# AVALON DUPLEX

93 CENTRAL ROAD, AVALON NSW 2107

# FOR COMPLYING DEVELOPMENT

C	FOR CDC APPROVAL	22/2/2024
B	CONSULTANT COORDINATION	9/10/2023
A	FOR COMPLYING DEVELOPMENT	31/8/2023
P1	FOR CONSULTANT COORDINATION	22/8/2023
REV	STATUS	DATE

**1 GROUND FLOOR PLAN**  
1:50 @ A1

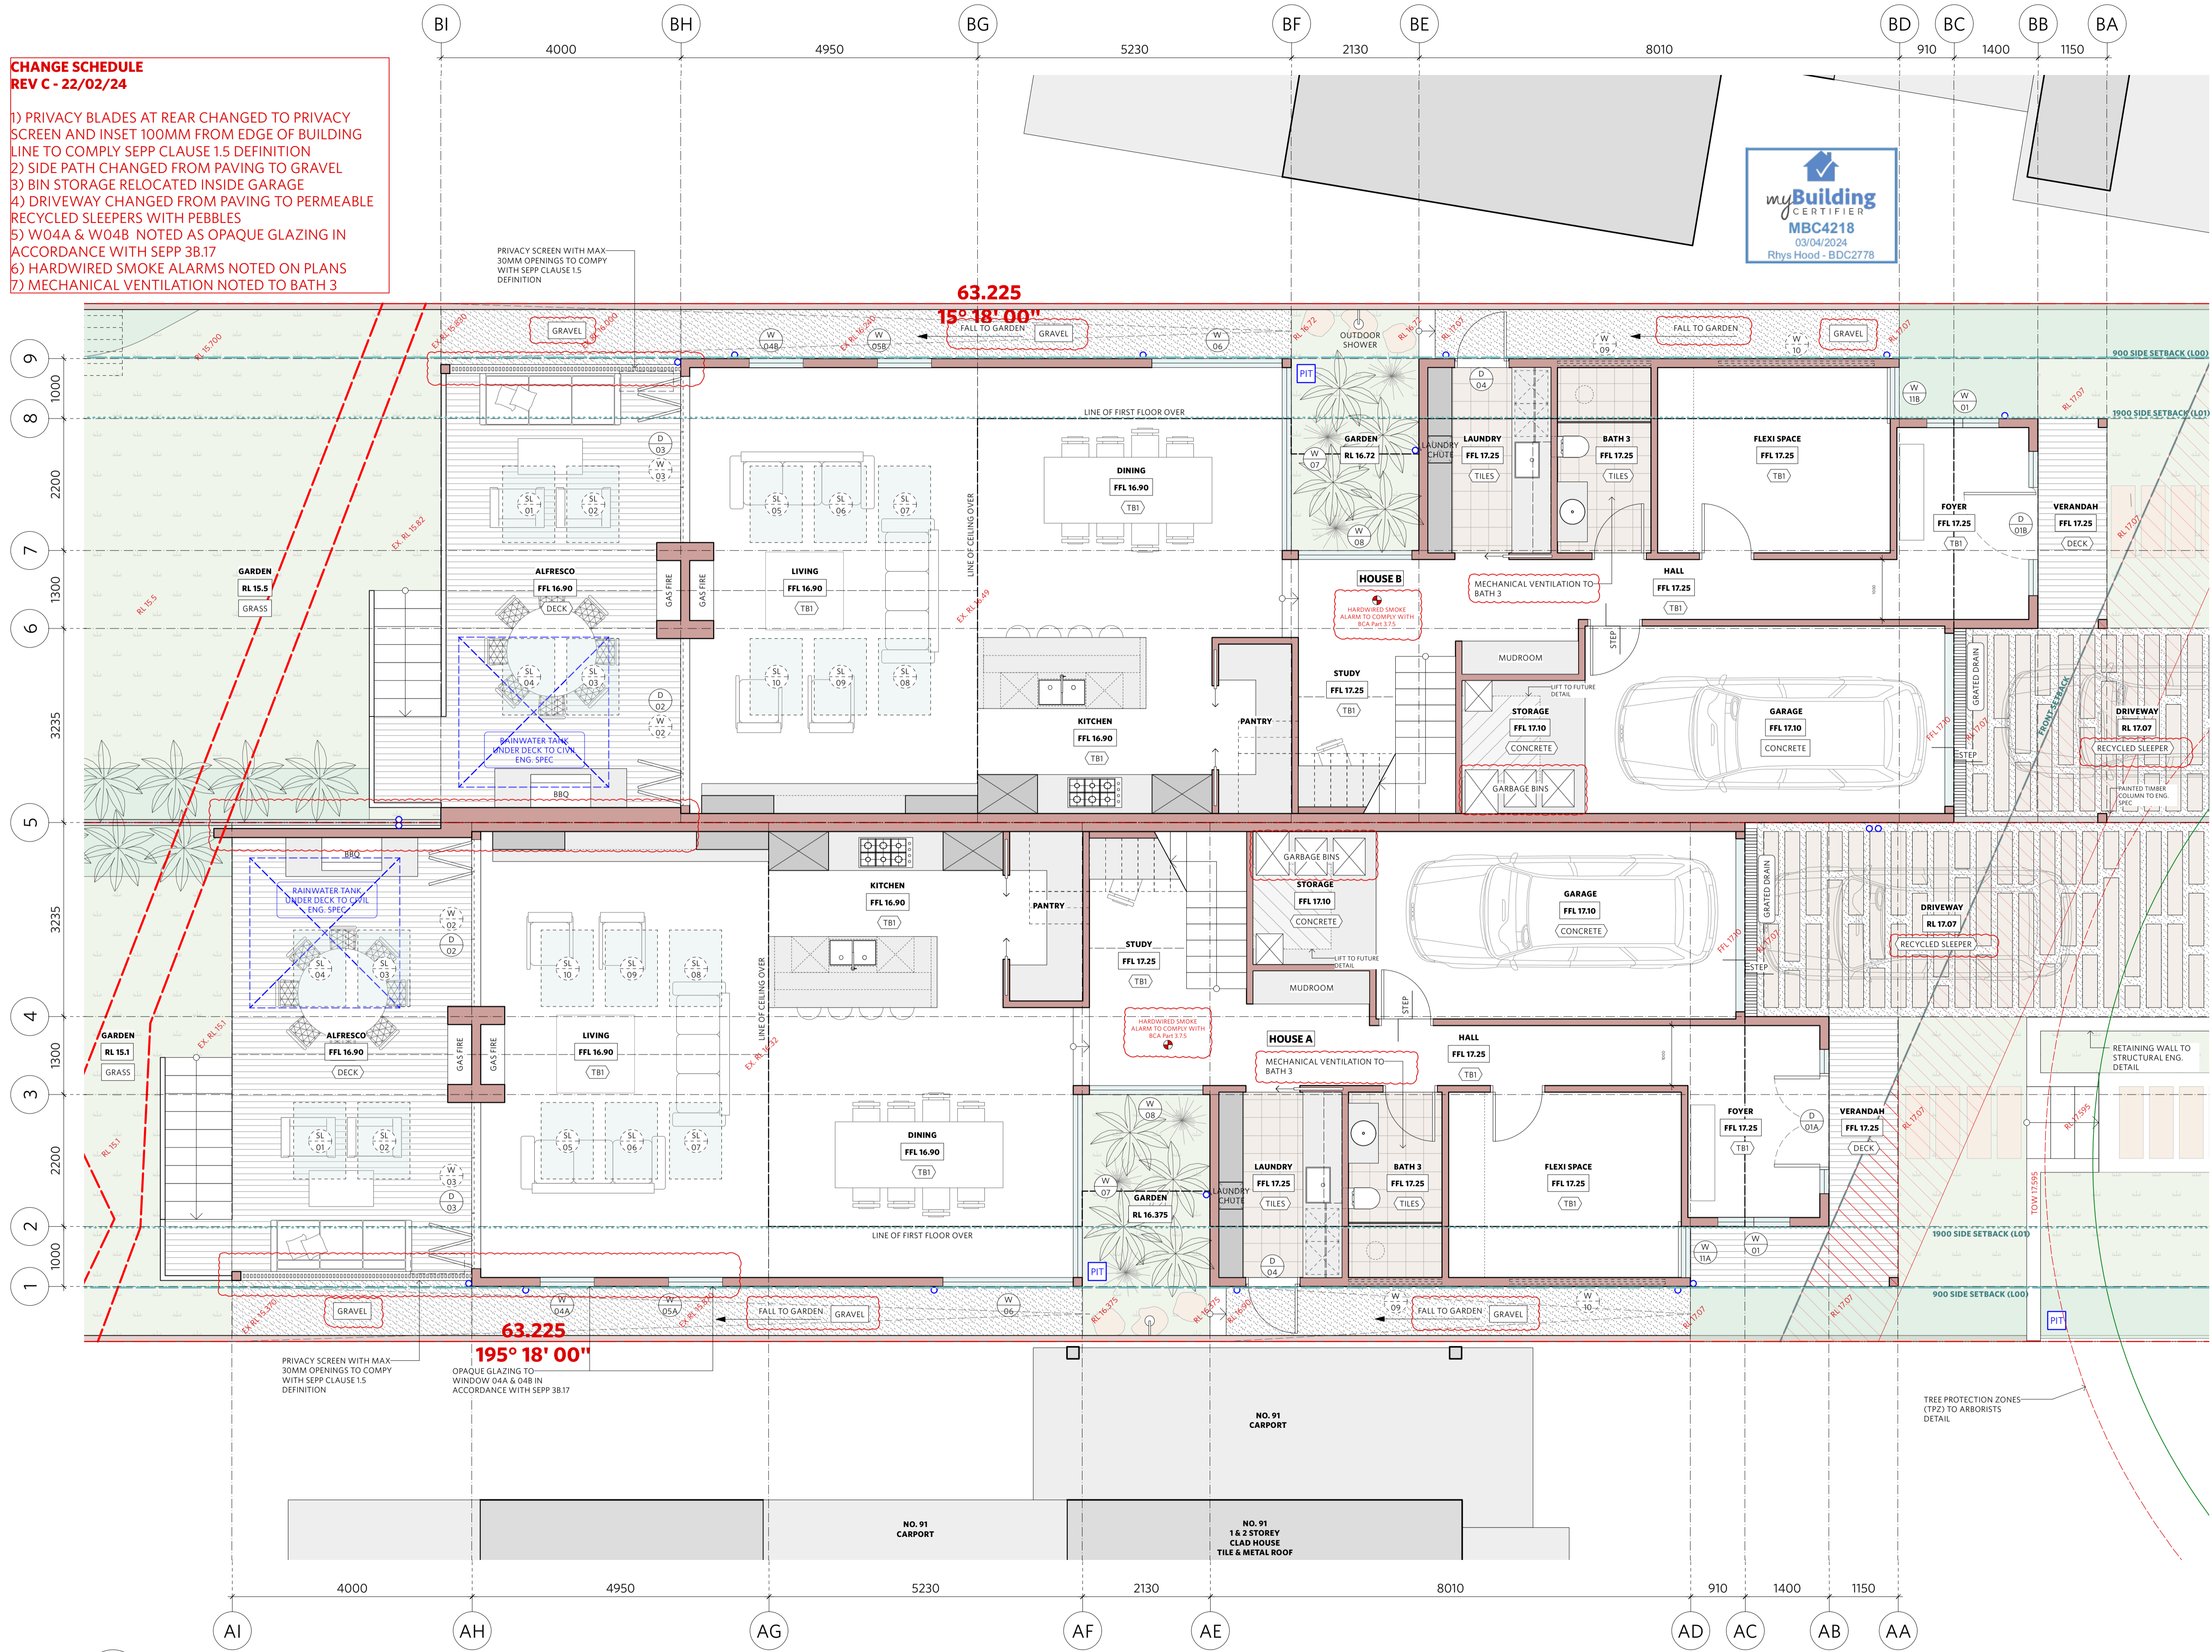
- 1) PRIVACY BLADES AT REAR CHANGED TO PRIVACY SCREEN AND INSET 100MM FROM EDGE OF BUILDING LINE TO COMPLY SEPP CLAUSE 1.5 DEFINITION
- 2) SIDE PATH CHANGED FROM PAVING TO GRAVEL
- 3) BIN STORAGE RELOCATED INSIDE GARAGE
- 4) DRIVEWAY CHANGED FROM PAVING TO PERMEABLE RECYCLED SLEEPERS WITH PEBBLES
- 5) W04A & W04B NOTED AS OPAQUE GLAZING IN ACCORDANCE WITH SEPP 3B.17
- 6) HARDWIRED SMOKE ALARMS NOTED ON PLANS
- 7) MECHANICAL VENTILATION NOTED TO BATH 3

**1** FIRST FLOOR PLAN  
 1:50 @ A1

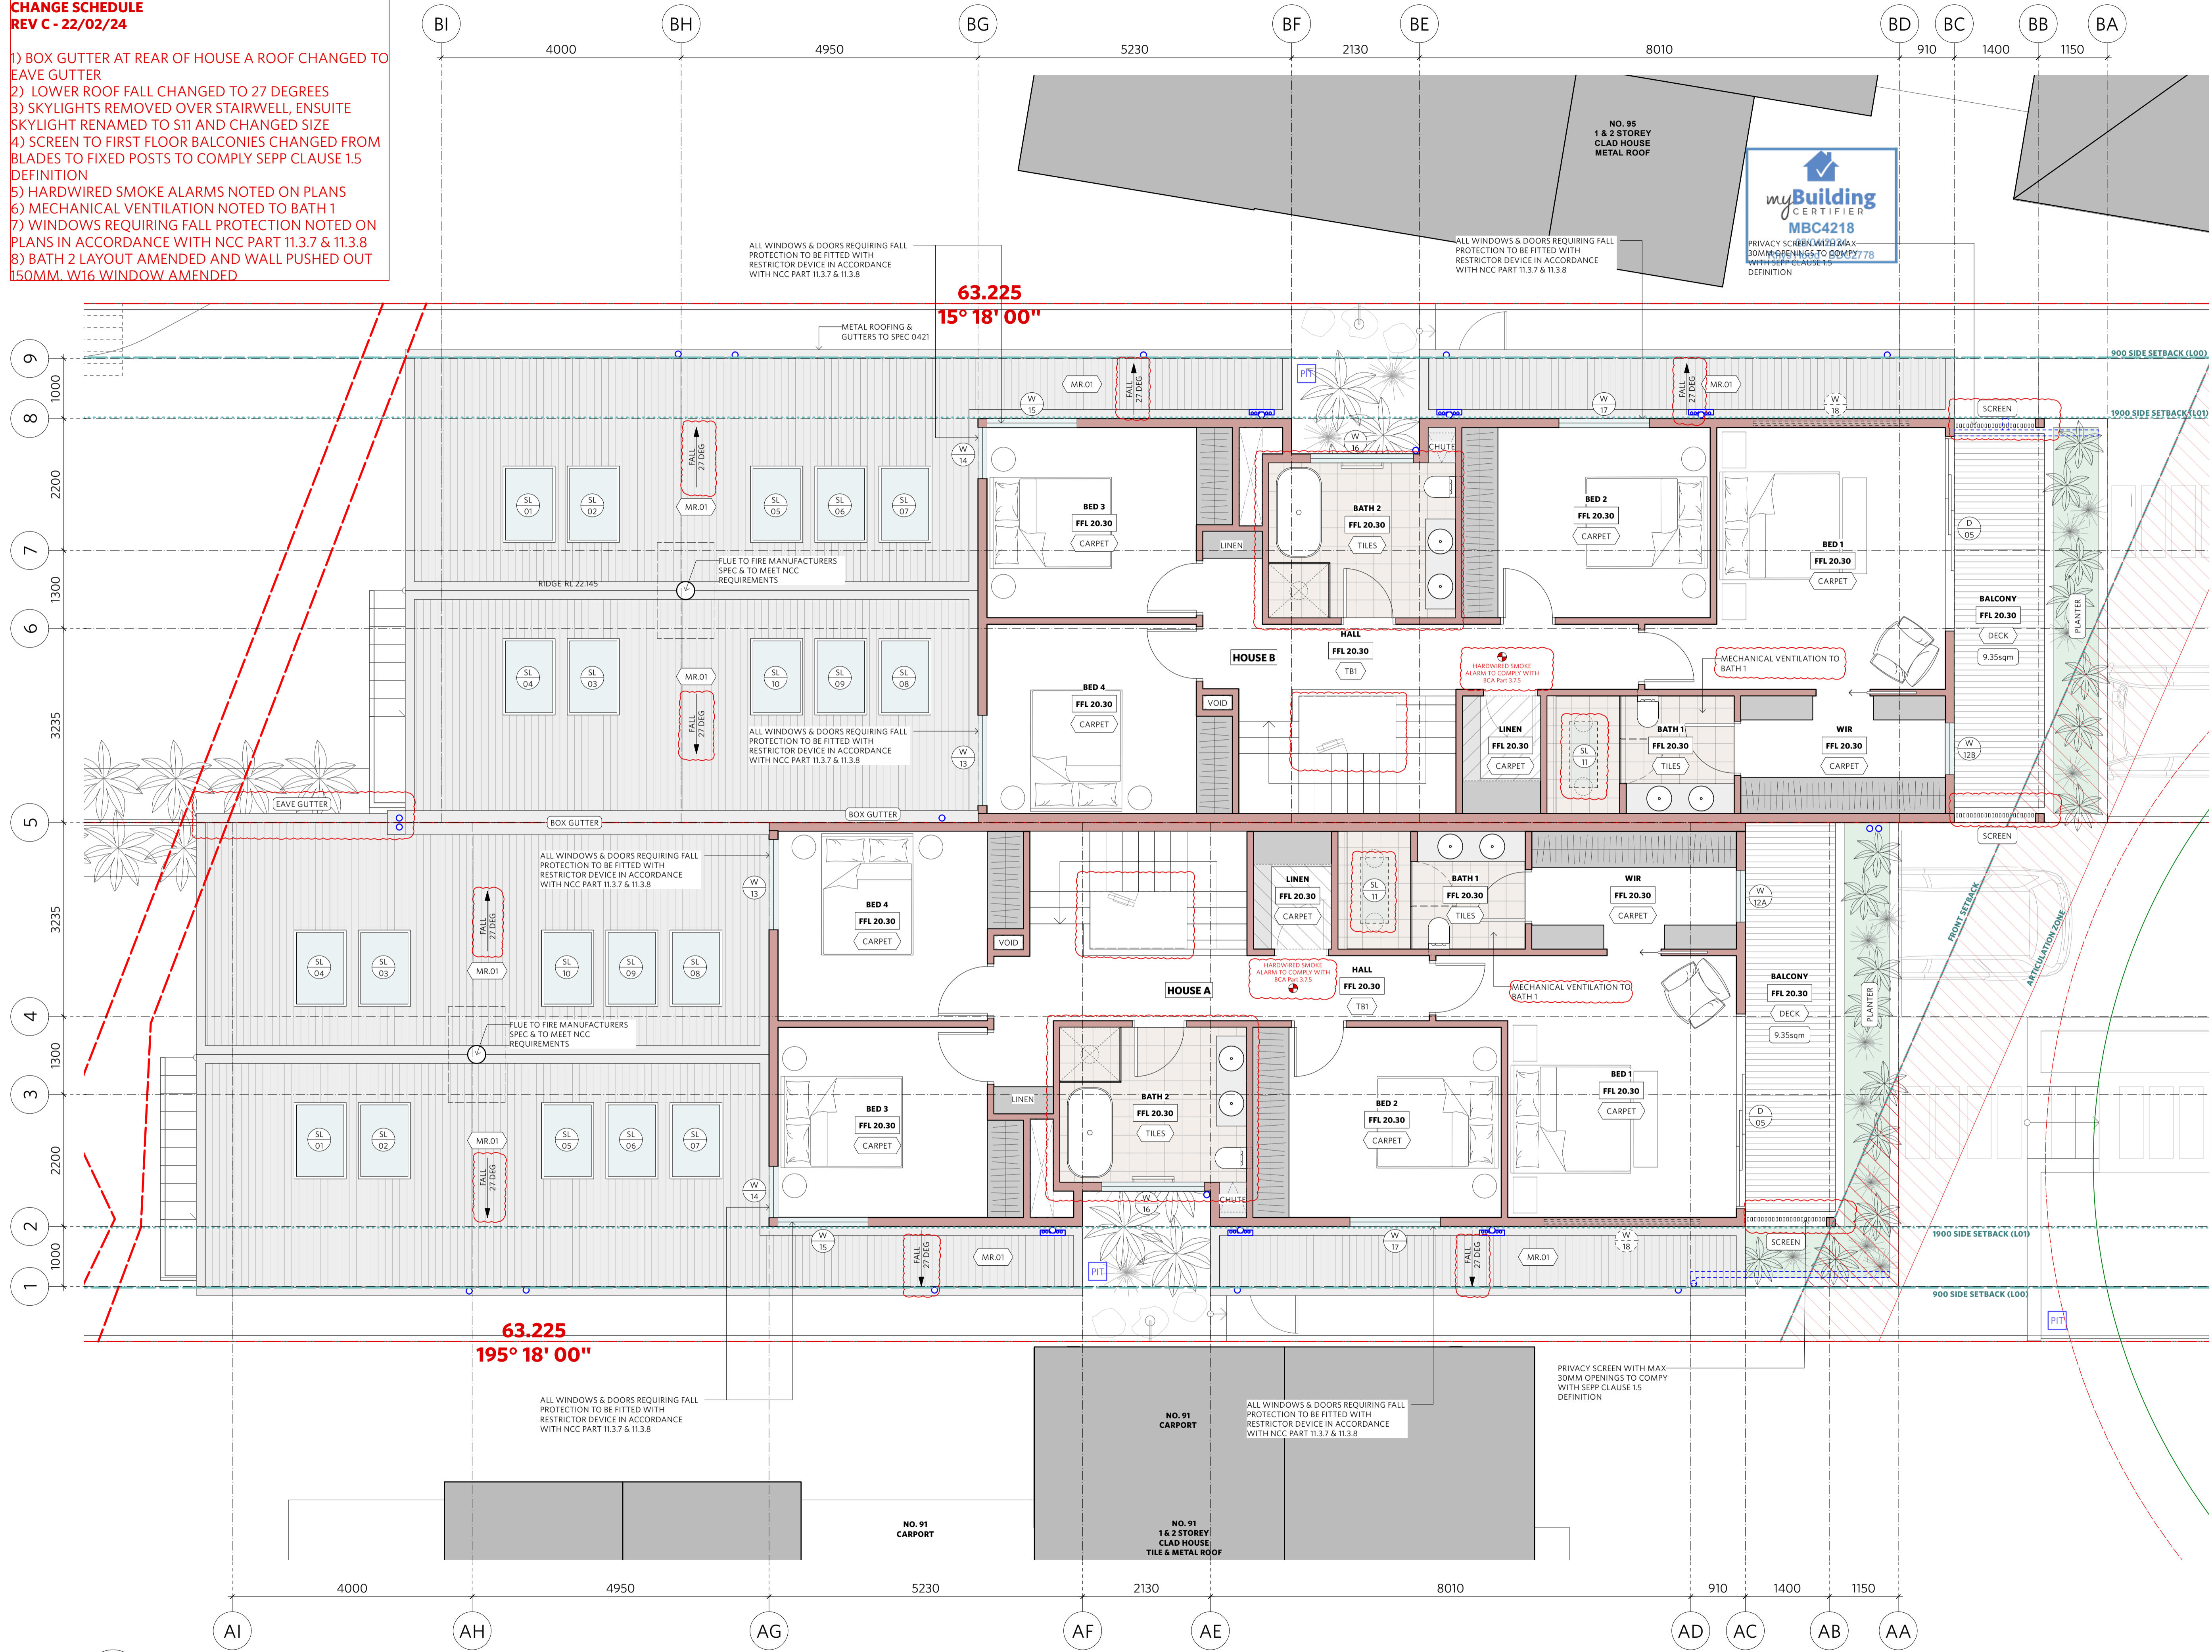
- CHANGE SCHEDULE**  
**REV C - 22/02/24**
- 1) BOX GUTTER AT REAR OF HOUSE A ROOF CHANGED TO EAVE GUTTER
  - 2) LOWER ROOF FALL CHANGED TO 27 DEGREES
  - 3) SKYLIGHTS REMOVED OVER STAIRWELL, ENSUITE SKYLIGHT RENAMED TO S11 AND CHANGED SIZE
  - 4) SCREEN TO FIRST FLOOR BALCONIES CHANGED FROM BLADES TO FIXED POSTS TO COMPLY SEPP CLAUSE 1.5 DEFINITION
  - 5) HARDWIRED SMOKE ALARMS NOTED ON PLANS
  - 6) MECHANICAL VENTILATION NOTED TO BATH 1
  - 7) WINDOWS REQUIRING FALL PROTECTION NOTED ON PLANS IN ACCORDANCE WITH NCC PART 11.3.7 & 11.3.8
  - 8) BATH 2 LAYOUT AMENDED AND WALL PUSHED OUT 150MM. W16 WINDOW AMENDED

**1 ROOF PLAN**  
1:50 @ A1

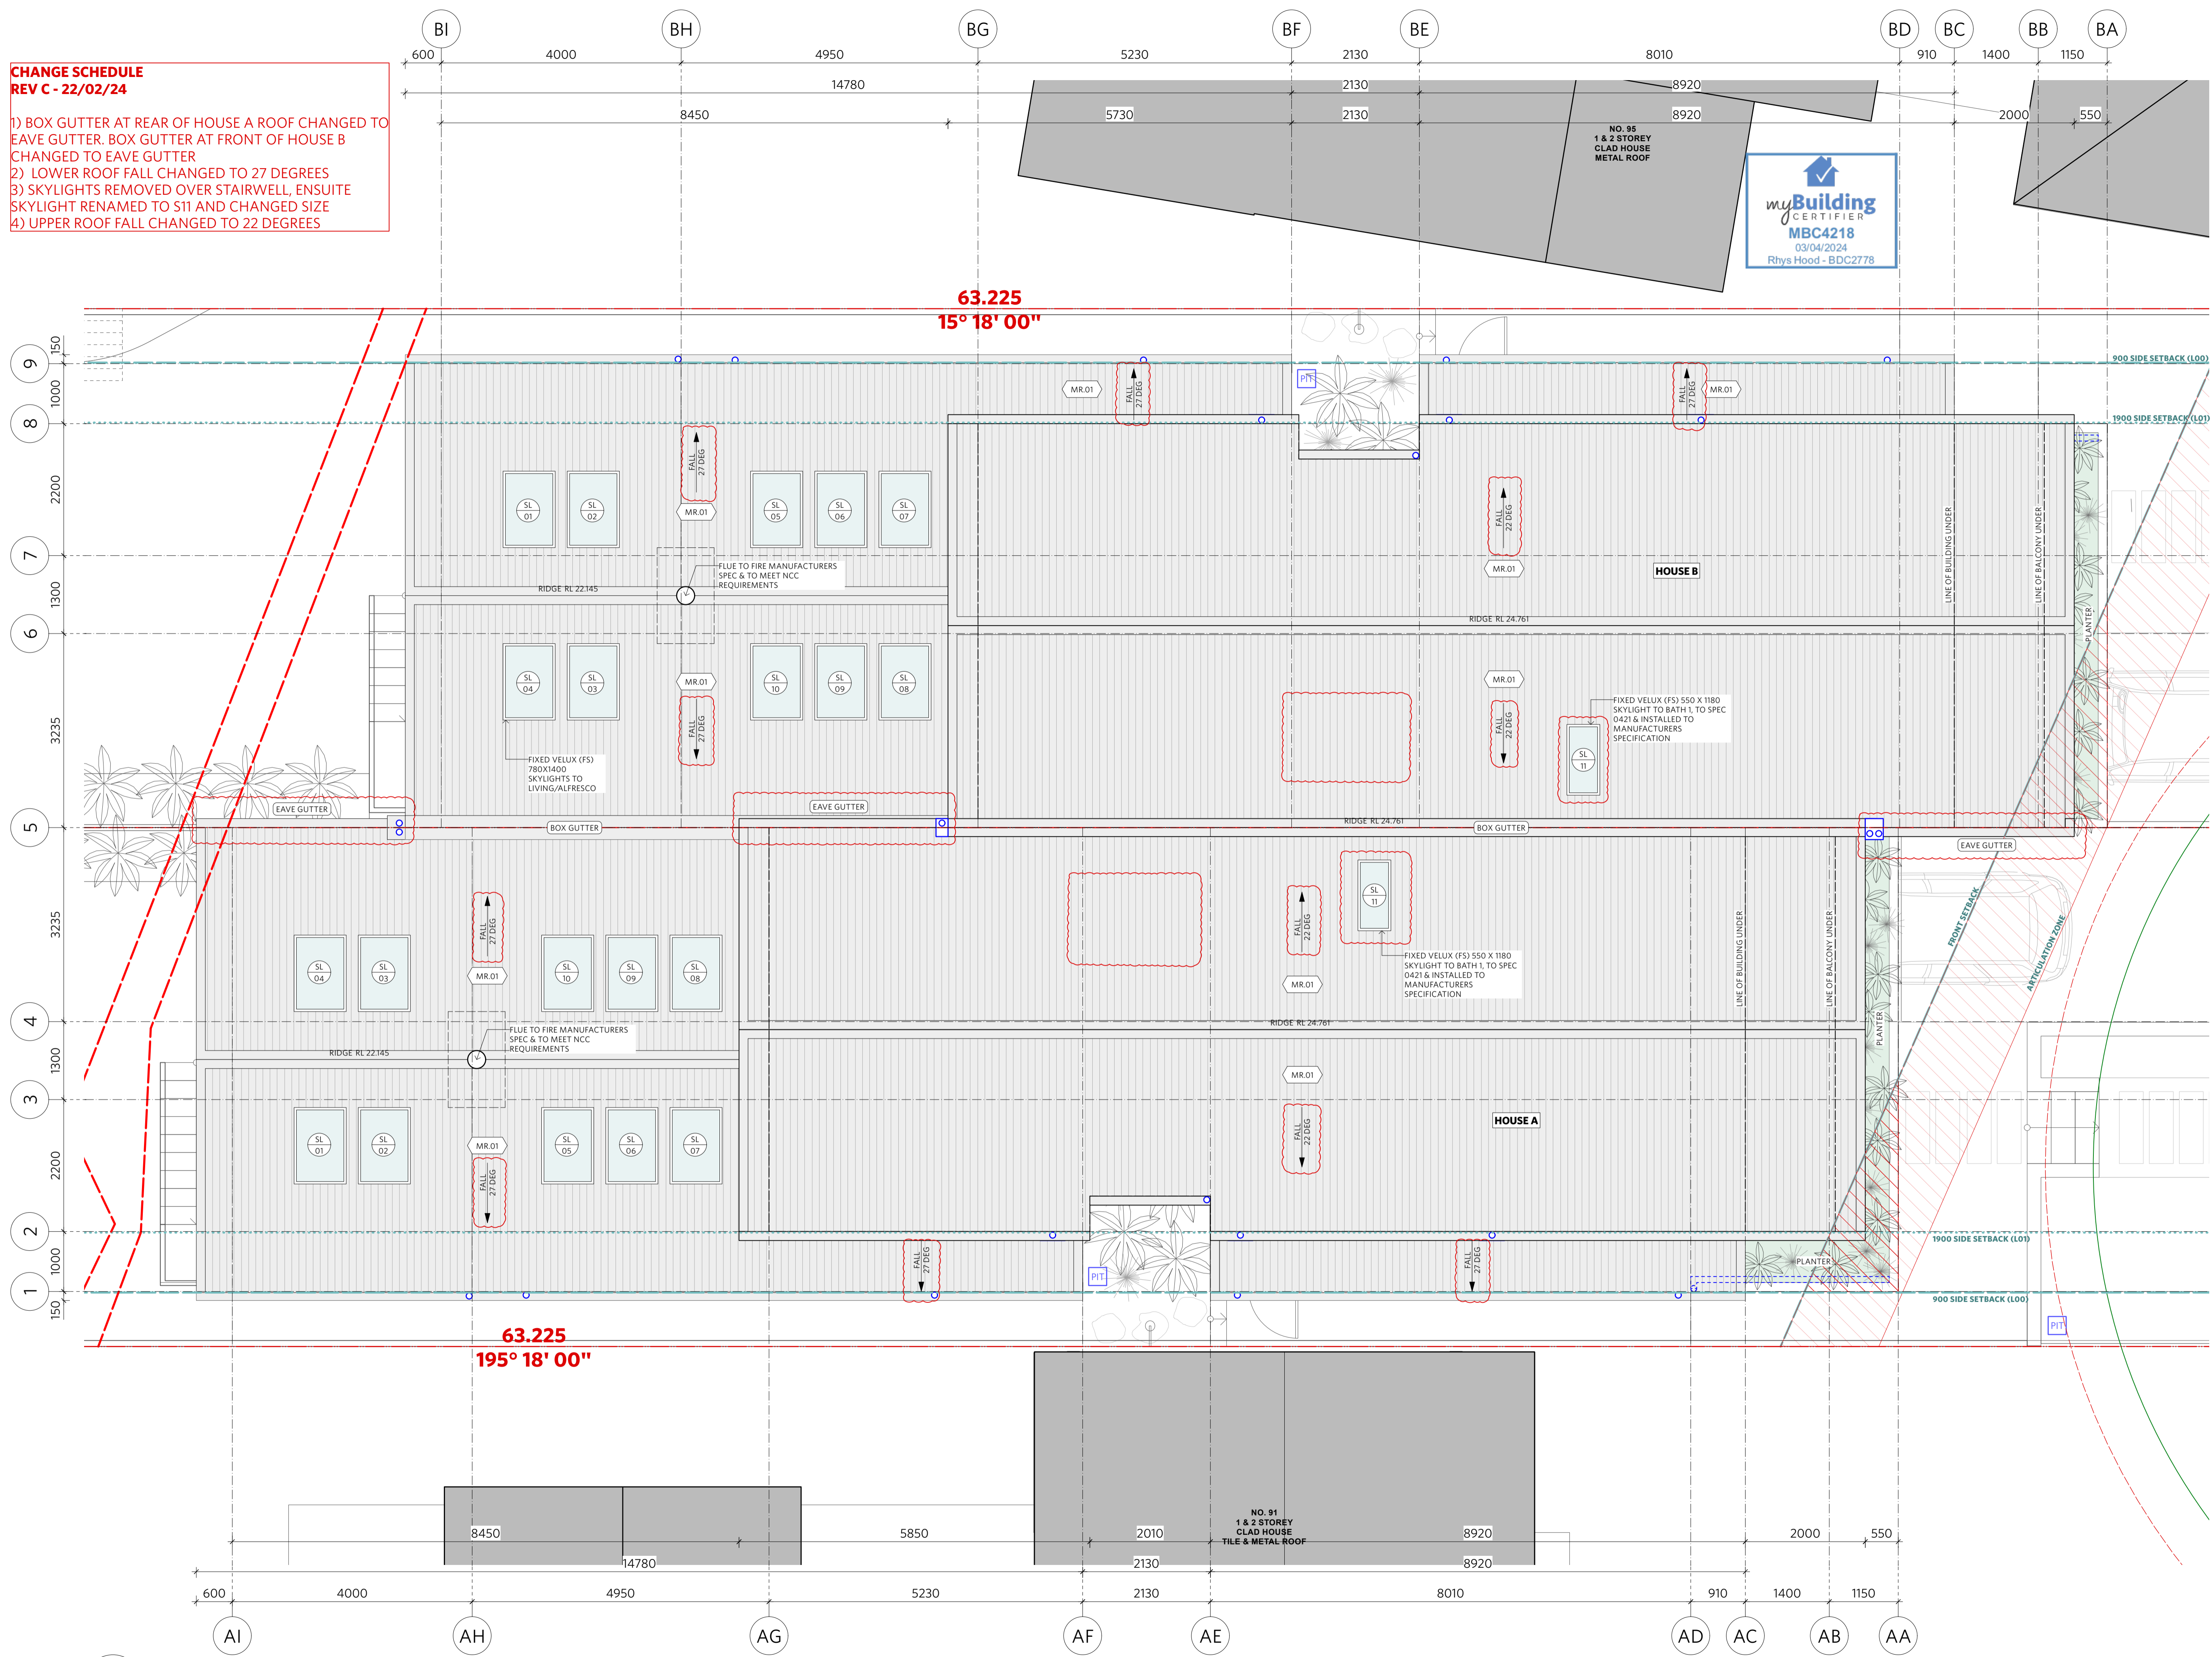
- 1) BOX GUTTER AT REAR OF HOUSE A ROOF CHANGED TO EAVE GUTTER. BOX GUTTER AT FRONT OF HOUSE B CHANGED TO EAVE GUTTER
- 2) LOWER ROOF FALL CHANGED TO 27 DEGREES
- 3) SKYLIGHTS REMOVED OVER STAIRWELL, ENSUITE SKYLIGHT RENAMED TO S11 AND CHANGED SIZE
- 4) UPPER ROOF FALL CHANGED TO 22 DEGREES
